DS #: 4684

PROJECT: Skye Canyon - Parcel 1.3

SUBMITTAL: 1st

CITY OF LAS VEGAS			DATE:			
INTER-OFFICE MEMORANDUM			August 11, 2014			
TO: Land Development Services Department of Building & Safety			FROM: Albert Sung, P.E. Flood Control Project Engineer Department of Public Works			
SUBJECT: Drainage Study for: Skye Canyon – Parcel 1.3			COPIES TO: Slater Hanifan Group			
Cross Streets: NEC Grand Teton Drive & Hualapai Way			K A G Development South, LLC / Ninety-Five Management, LLC			
File Number: F:\Depot\DSMemos\DS4684A.doc			Bart Anderson, P.E., DevCo			
Parcel Number: 125-07-401-001			CCRFCD			
Zoning Action: TMP-53908						
FEMA Flood Zone		YES			NO	X
Proposed Storm Drain		YES			X	NO

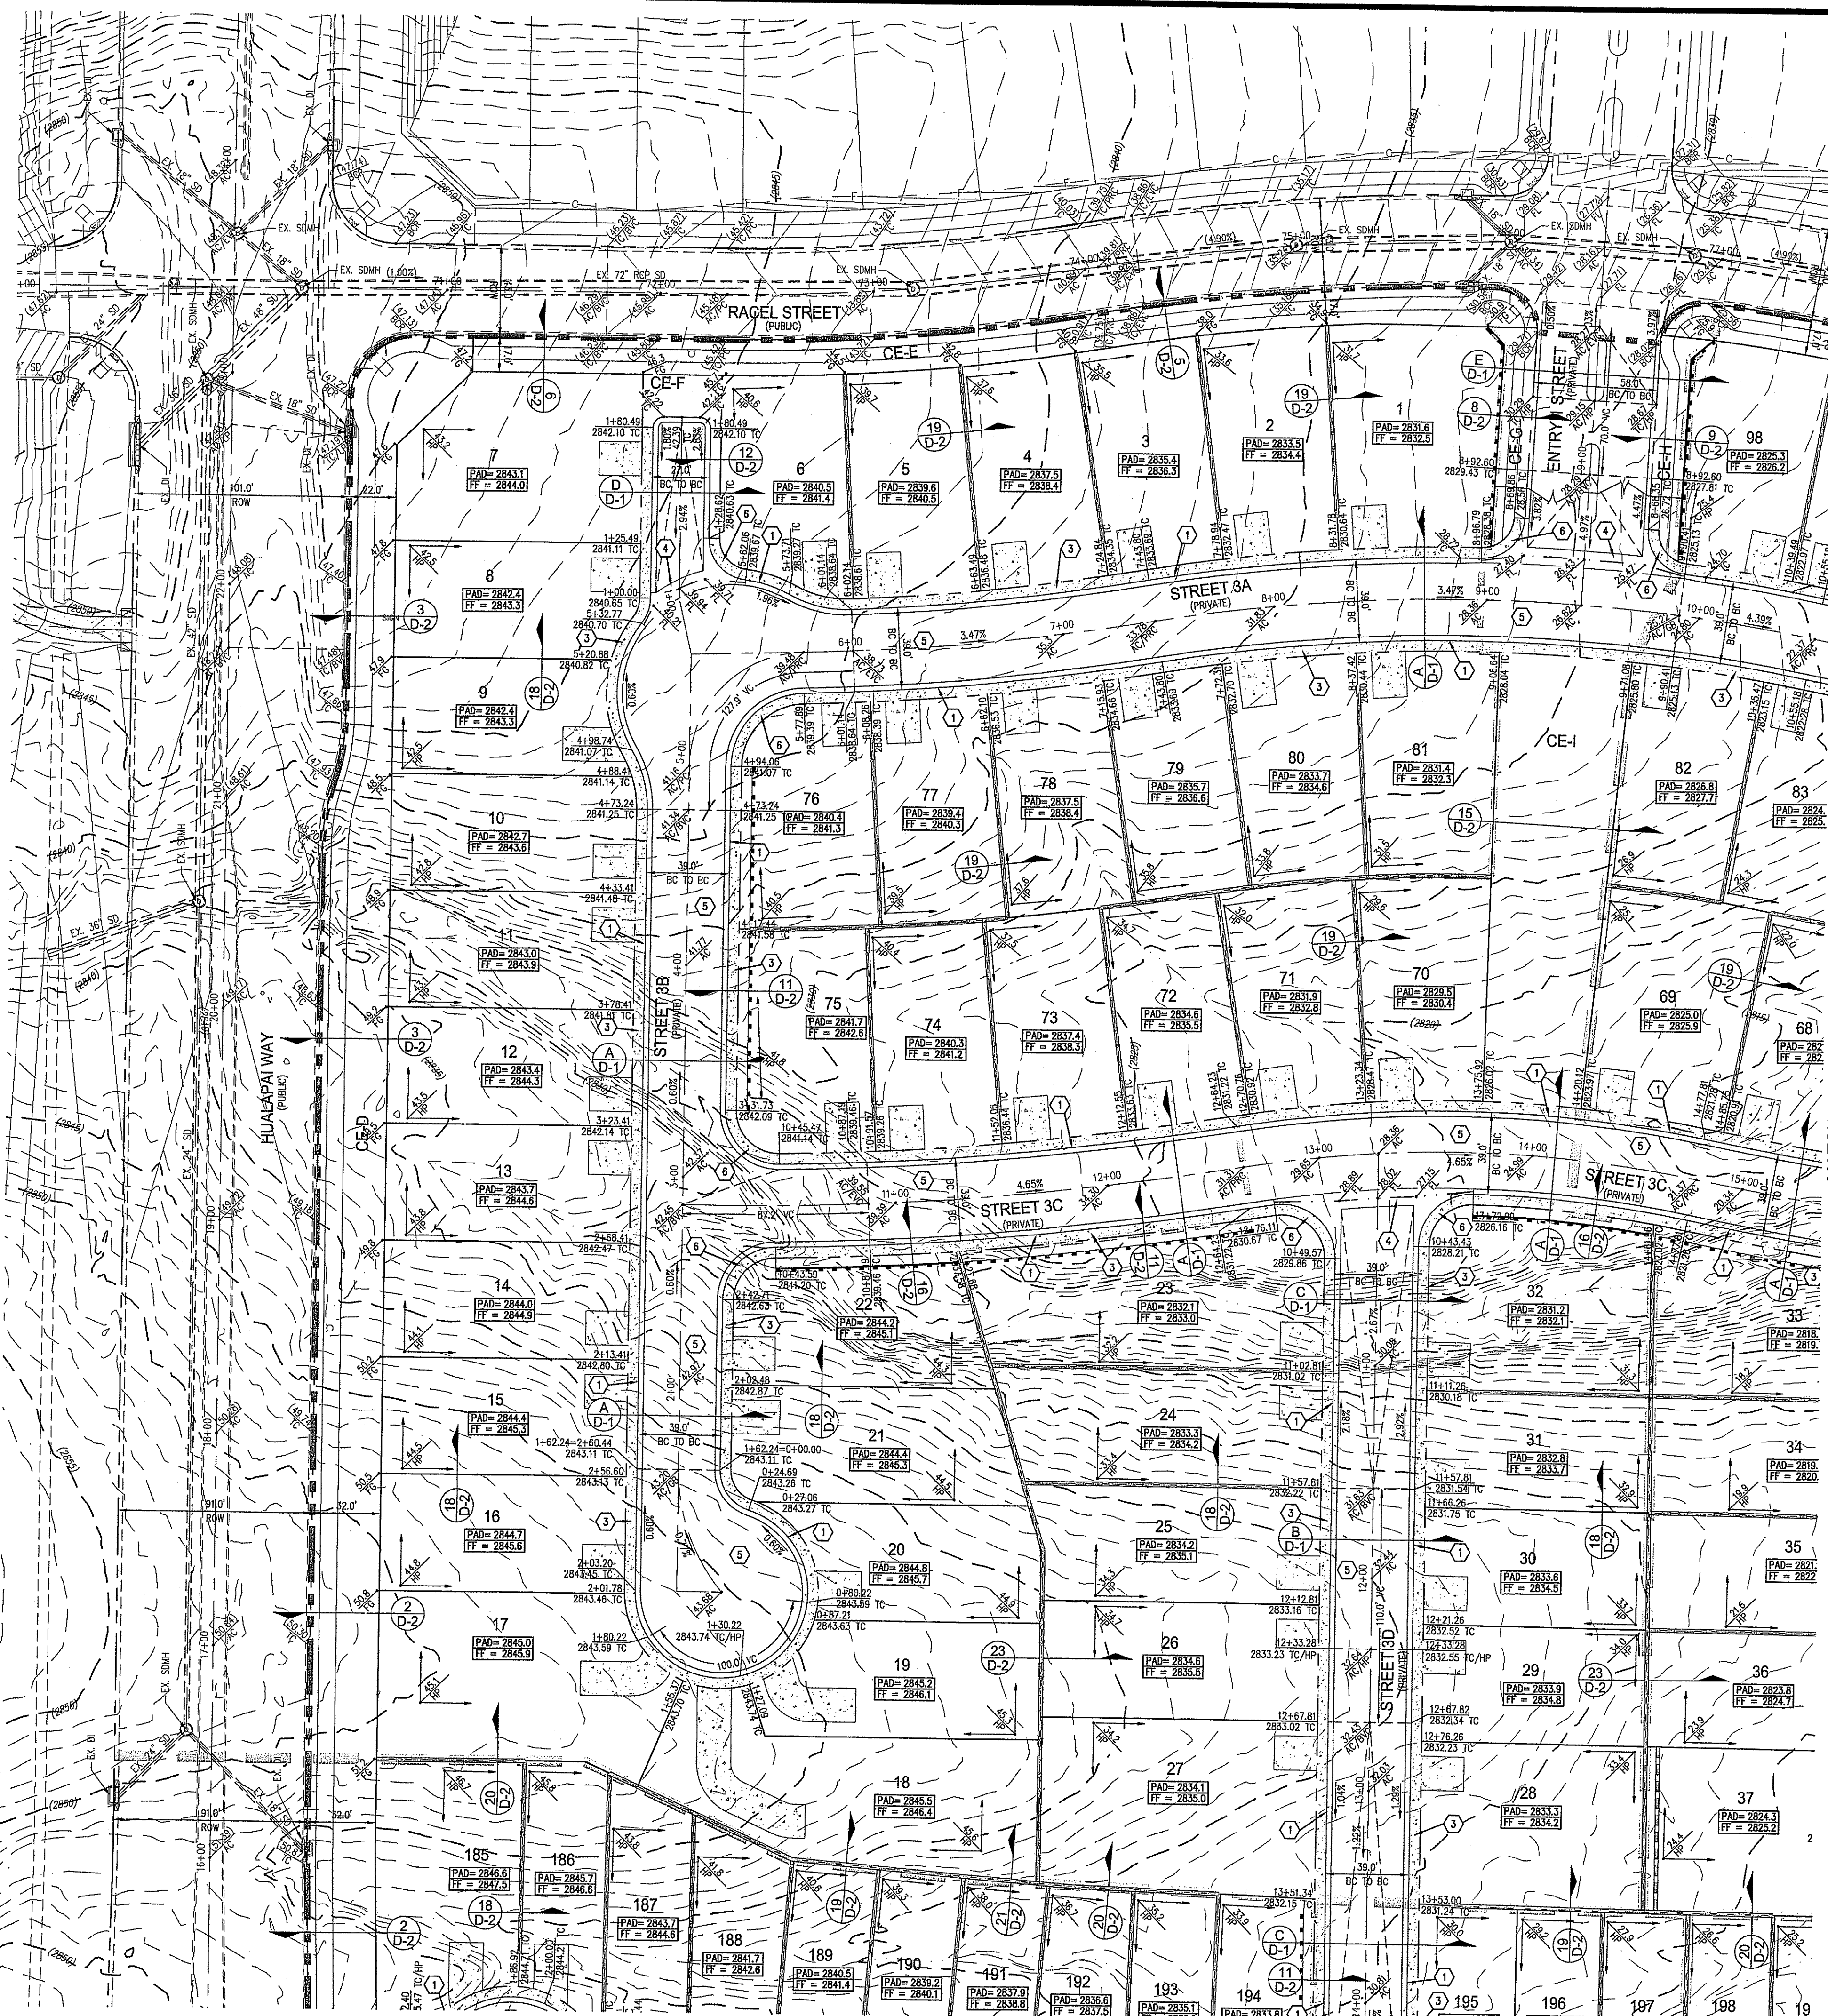
5. **Grading Plans G-1 and G-2:** In a worst case scenario that the 100-year flow depth of 1.77' in *Racel Street*, **Entry 1 Street** appears to overflow some of the flood in *Racel* split into the onsite development and continue east on **Street 3A**. Provide hydraulic calculation to quantify how much flow will split into the site downstream of the intersection of **Entry 1 Street** and **Street 3A** under the worst case situation. Address whether the proposed finished floor elevations of those impacted lots are still above the worst case flood.
6. **Grading Plan G-2:** In **Street 3C**, a bypassed flow of 17.5 cfs (29.5 cfs – 12 cfs at D.I. #5) will go east and impacting Lots 55 – 57. It is recommended to provide another equal length D.I. about 20' downstream of D.I. #5 to reduce the flow draining in front of the three lots. Review and revise accordingly.

Address during a worst case scenario, the ponding depth at the sump is less than 1' for it to overflow into **Street E** for discharge.

Dedicate the piece of land between the end of **Street 3C** and the right-of-way line of **Street E** as a common lot and public drainage easement (privately maintained by the HOA) on the grading plan and the final map.

G-3
SHEET 5 OF 10

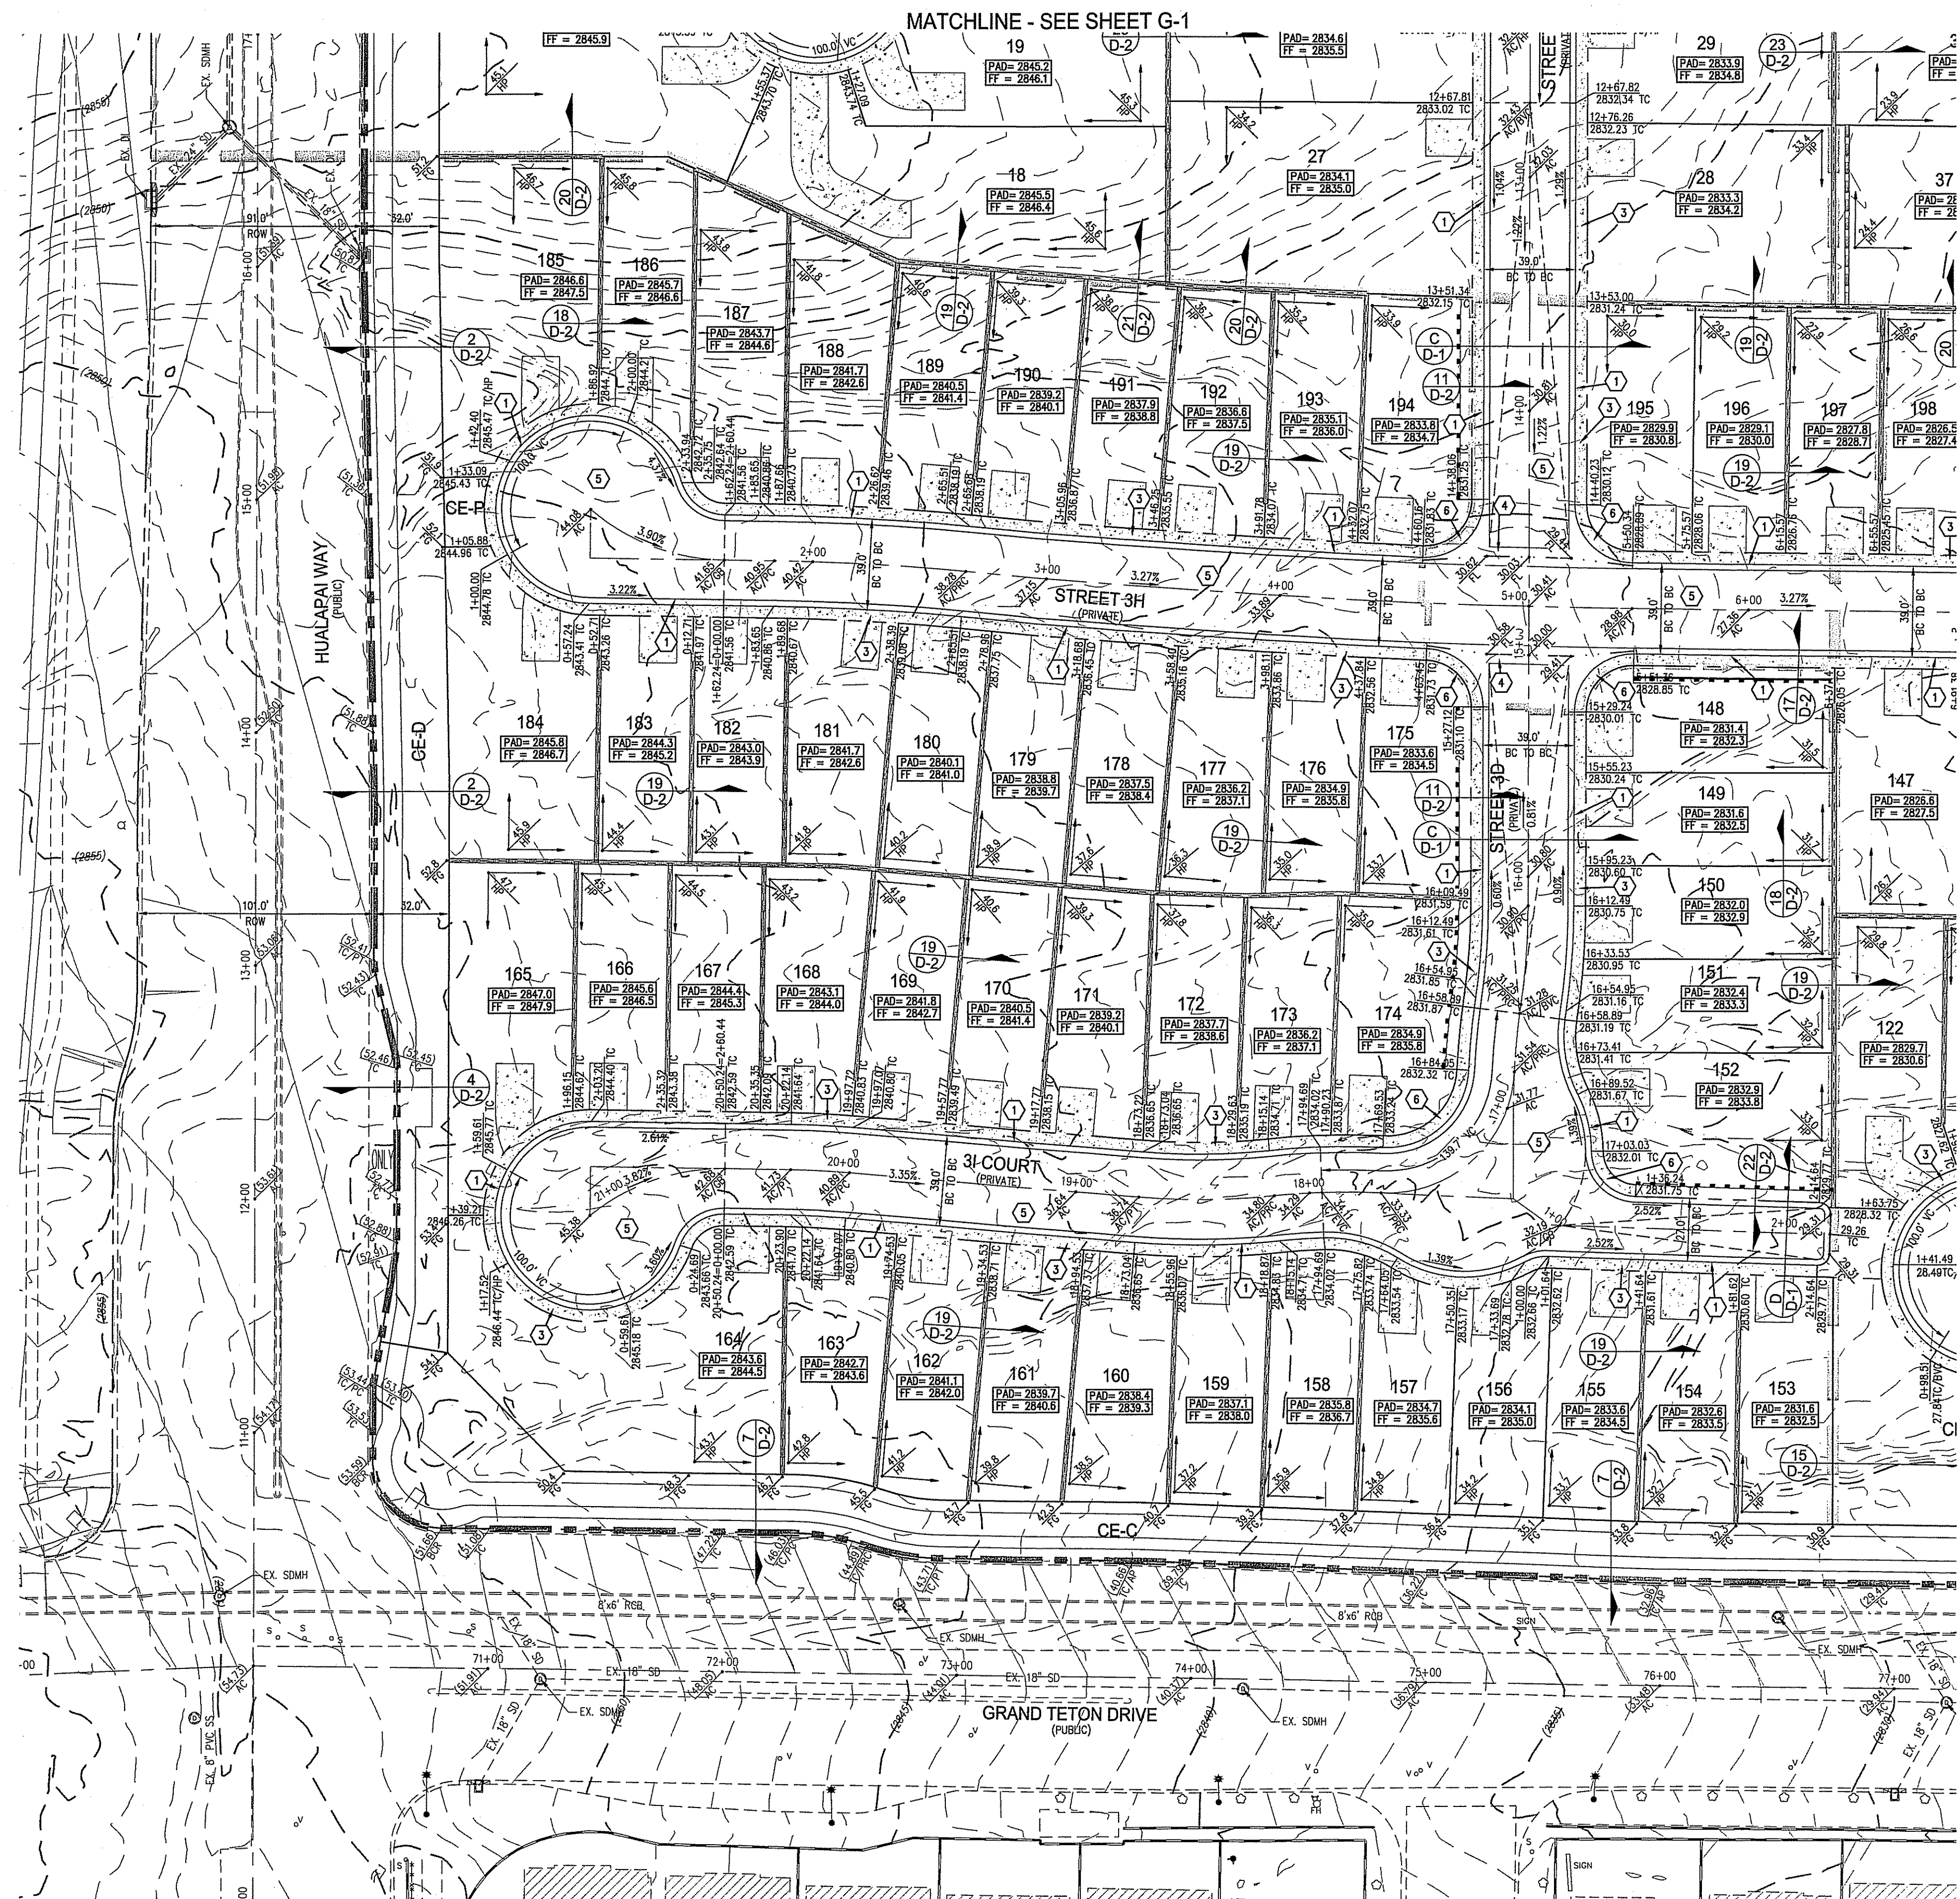
7. **Grading Plans G-3 and G-4:** Dedicate the piece of land between the east end of **Street 3I Court** and the bulb of cul-de-sac of **Street 3J Court** as a common lot and public drainage easement (privately maintained by the HOA) on the grading plan and the final map.

G-4: Label finished floor elevations of the lots in the adjacent **Parcel 1.4** to the east.
